Subject: **Tennessee Valley Authority's Browns Ferry Nuclear Plant Second Six-Month Status Report in Response to the June 6, 2013 Commission Order Modifying Licenses with Regard to Reliable Hardened Containment Vents Capable of Operation Under Severe Accident Conditions (Order-Number EA-13-109)**

### TENNESSEE VALLEY AUTHORITY BROWNS FERRY NUCLEAR PLANT'S SECOND SIX-MONTH STATUS REPORT FOR THE IMPLEMENTATION OF ORDER EA-13-109, "ISSUANCE OF ORDER MODIFYING LICENSES WITH REGARD TO RELIABLE HARDENED CONTAINMENT VENTS CAPABLE OF OPERATION UNDER SEVERE ACCIDENT CONDITIONS"

### Revision 1 of “Tennessee Valley Authority’s Phase 1 Overall Integrated Plan in Response to June 6, 2013 Commission Order Modifying Licenses with Regard to Reliable Hardened Containment Vents Capable of Operation Under Severe Accident (Order Number EA-13-109)”

### Figure 2 - Mechanical I&C Flow Diagram Control Air System

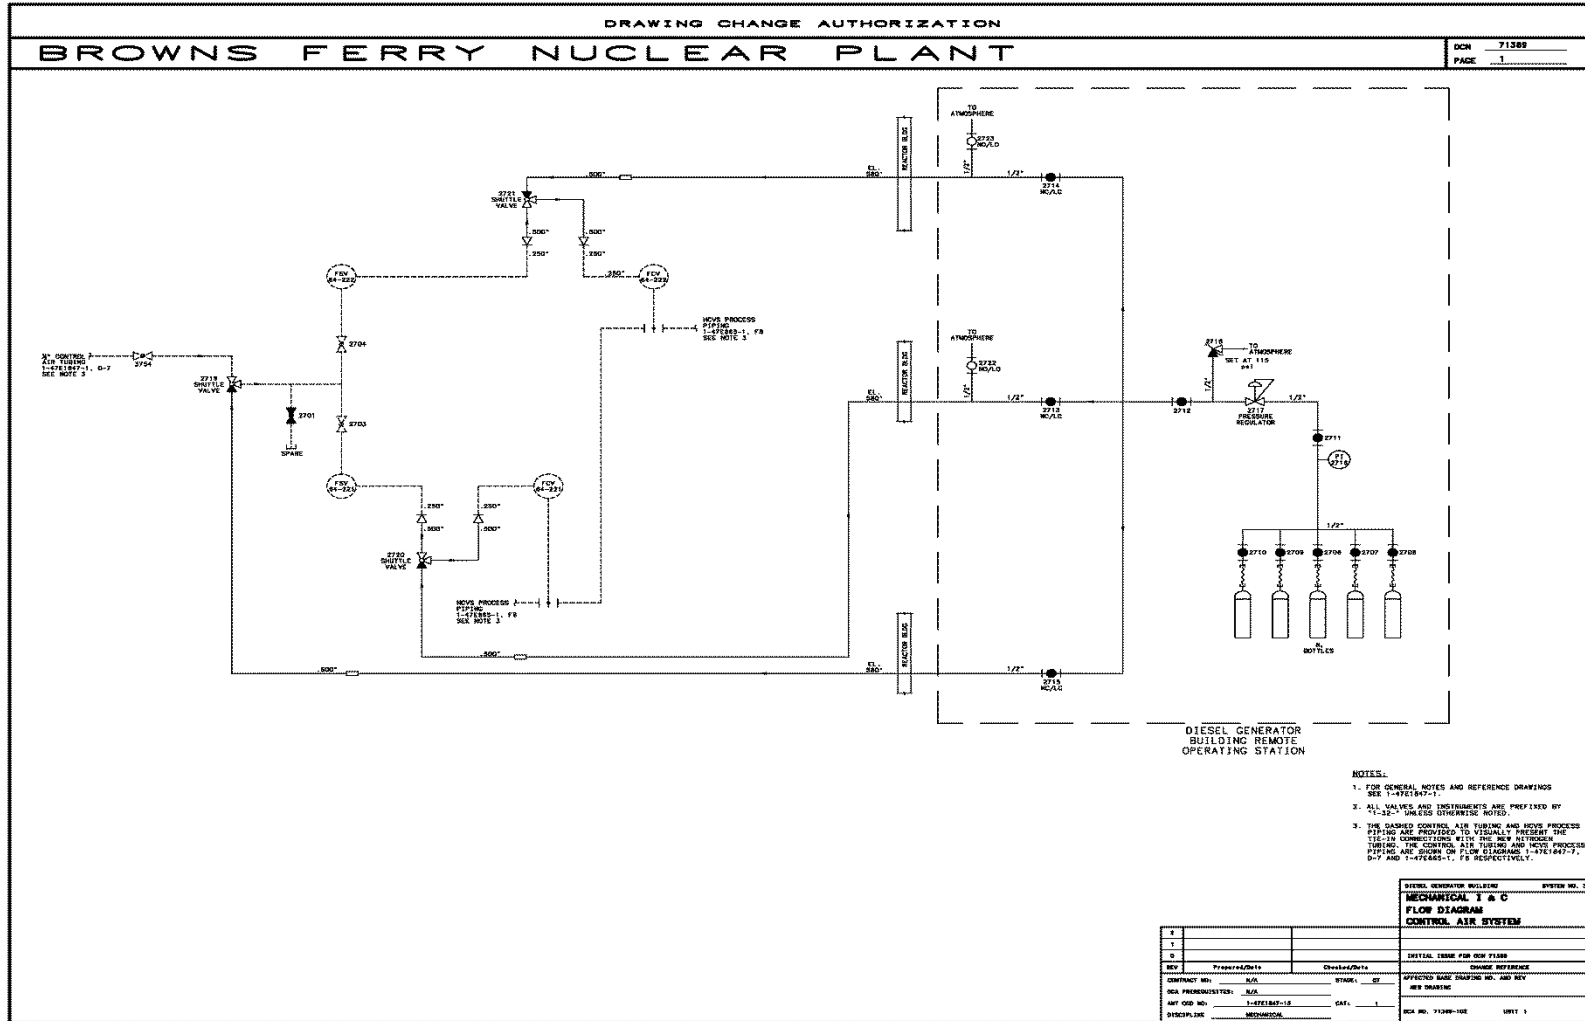
- Pages 38 and 39 of 59, Updated Table 4-1 “Testing and Inspection Requirements” to match Revision 1 of NEI 13-02.
- Pages 45 and 46 of 59, Updated Figures 2 and 3 to provide accurate description of the planned BFN design.
